REMARKS

Appl. No. 10/796,878 Amdt. Dated Mar. 1, 2005 Reply to Office action of Dec. 1, 2004

Amendments to the Drawings:

FIG. 1

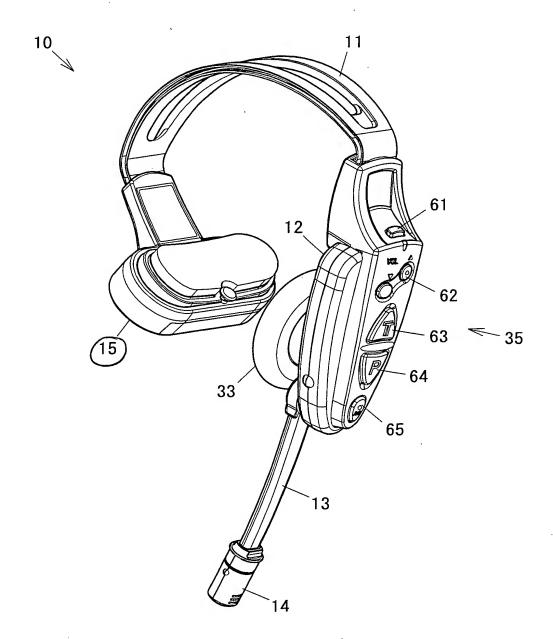
The Examiner has objected to the drawings. The corrections suggested by the Examiner have been incorporated into replacement sheets along with other minor reference numeral corrections. The proposed changes are indicated on the included annotated sheets.

Original FIG. 1, FIG. 2, and FIG. 3 should be replaced by new FIG. 1, FIG. 2, and FIG. 3 contained on new sheets each labeled "REPLACEMENT SHEET".
